## Highway Response in Respect of Mitigation Measures

Site: Land to the South of Funtley Road, Funtley  
Prepared by: DM  
Approved by: DM  
Date: 7 September 2021

Figure 3.1 – Revised Cycle Route Options

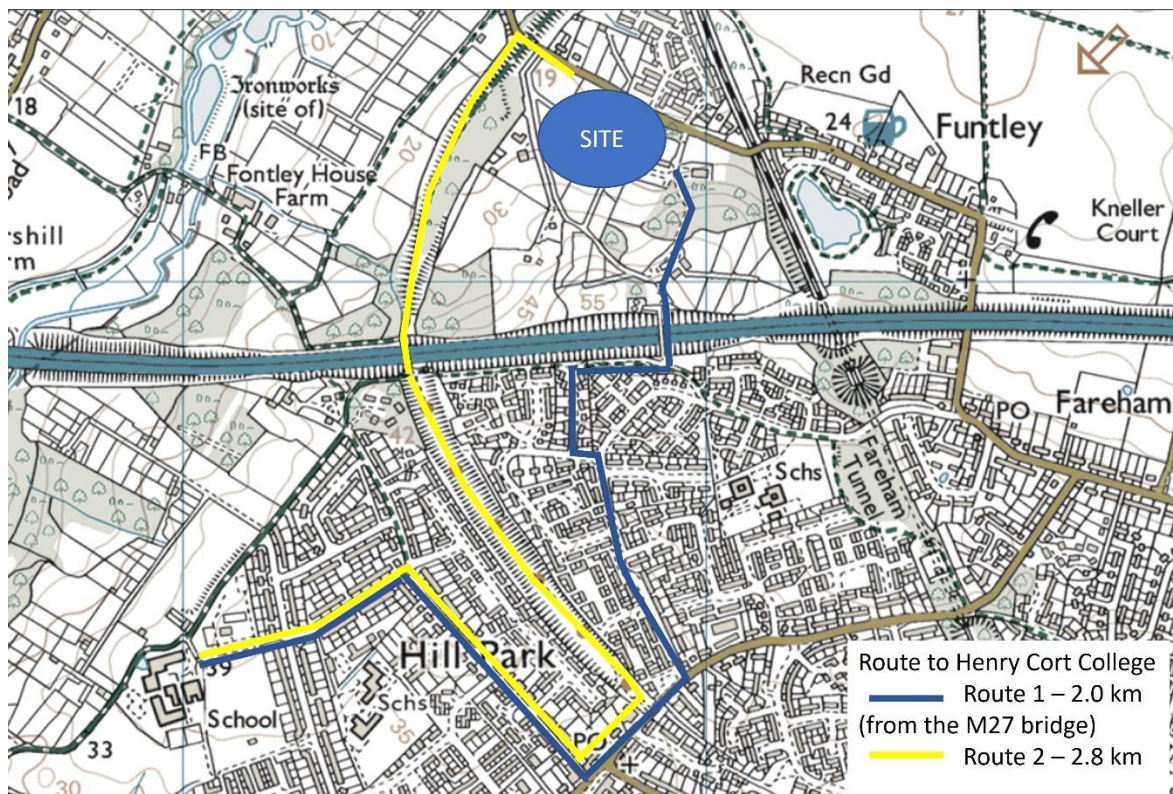
- 3.4 **Figure 3.1** below illustrates two alternative options:
- ▶ Route 1 via Thames Drive/ Highlands Road/Fareham Park Road; and
  - ▶ Route 2 via Funtley Road/Deviation Line/Highlands Road/Fareham Park Road.

- 3.5 Route 1 via Thames Drive extend to 2 kilometres (starting at the M27 bridge), which is comfortably within an acceptable cycle distance. Indeed, a Non-Motorised Users (NMU) Audit prepared to review connections to the college included this route as an option for residents (detailed later in this response note). The above route has been measured from the M27 bridge to the college to ensure consistency with the distances shown within the NMU Audit. The north/south route via the deviation line (route 2) for those residents residing towards the north-west of the development site extends to 2.8 kilometres, again well within an acceptable cycle distance.

- 3.6 Improvements to the section of existing footway connecting the M27 bridge with Thames Drive were secured as part of a previous 55 dwelling permission on this site. This improvement involved the widening of the footway to three metres to enable access by cyclists. Therefore the principle of cyclists travelling from the M27 bridge to Thames Drive, before routing south to Highlands Road, has already been established. On this basis there is nothing to stop future residents utilising a route to Henry Cort college which is designed for cyclists and extends to a distance well within acceptable travel distances.
